-  EXISTING RESIDENTIAL
-  CHANGE OF USE TO ECCE CHILDCARE FACILITY

Project	Change of Use Application No.4 Griffeen Glen Drive, Lucan, Co. Dublin		
Drawing	Site Drawings Proposed Floor Plans		
Project No	21038	Drawing No	PL-101
Scale	As shown	Revision	B

FURTHER INFORMATION
EQUATOR
architects
master-planners project managers
www.equator-architects.ie

Proposed Ground Floor Plan
Scale 1:100

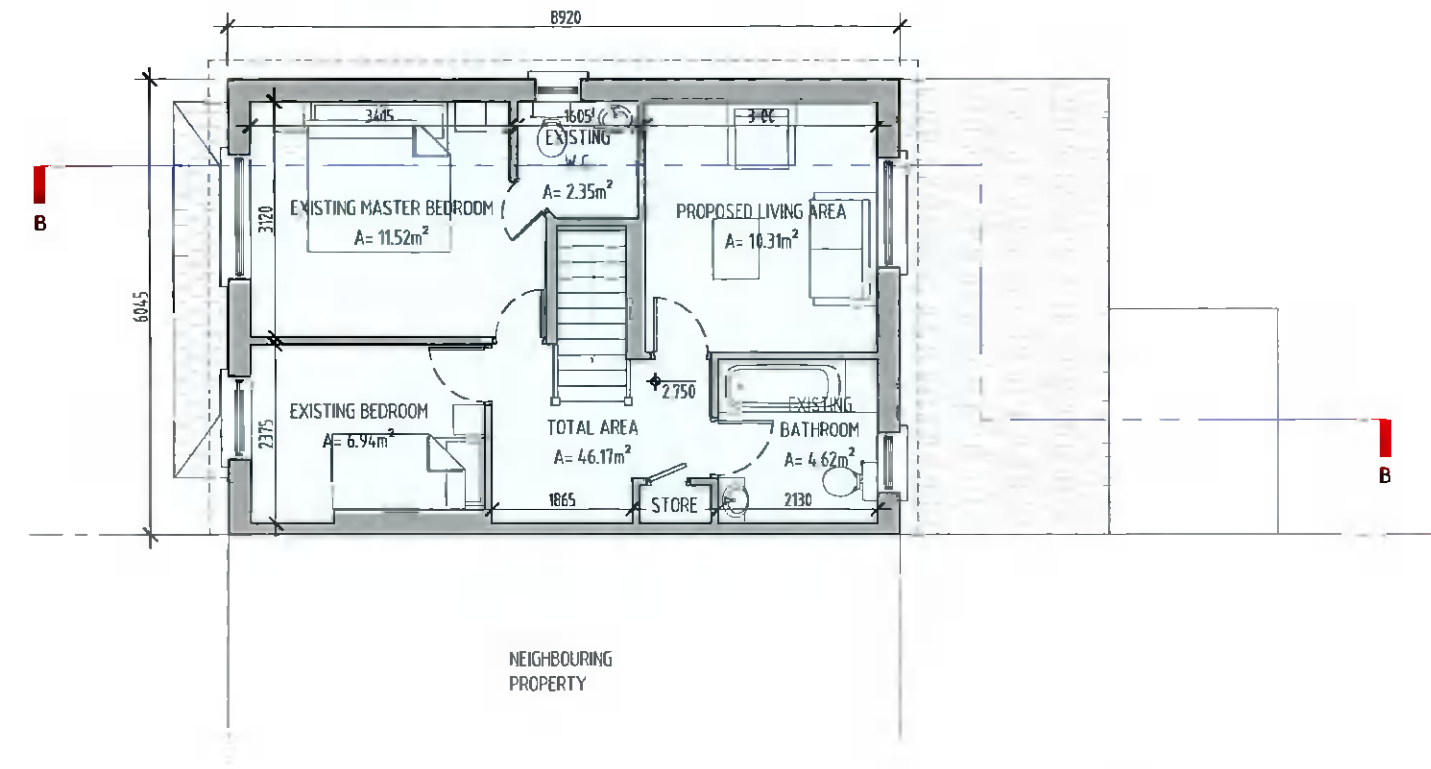
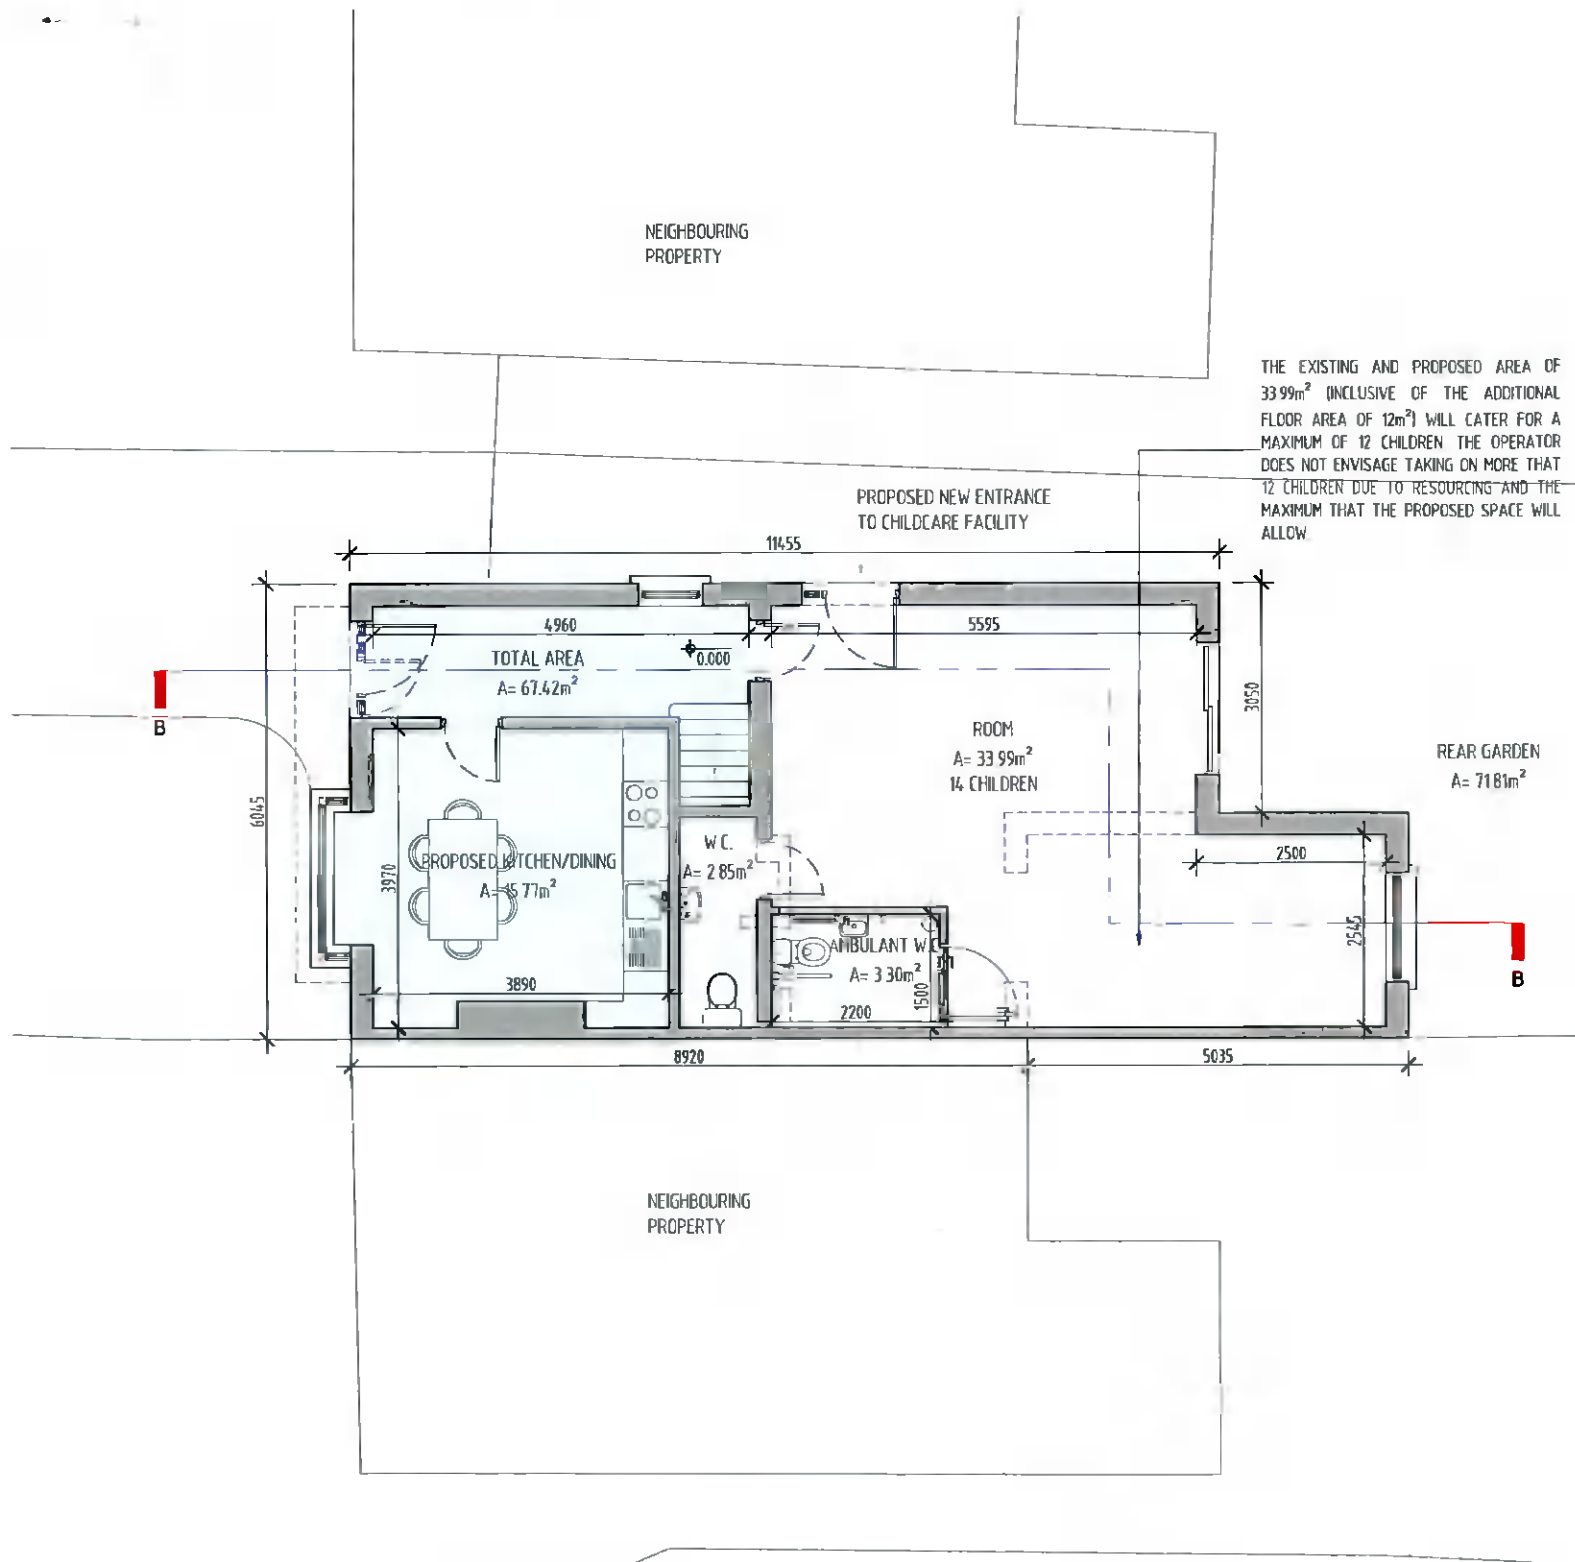
Revision	Date	Amendment	Author
A	26/07/2021	Issue for Planning	CT
B	01/04/2022	Existing residential area updated - RFI Clarification of additional floor area included	CT
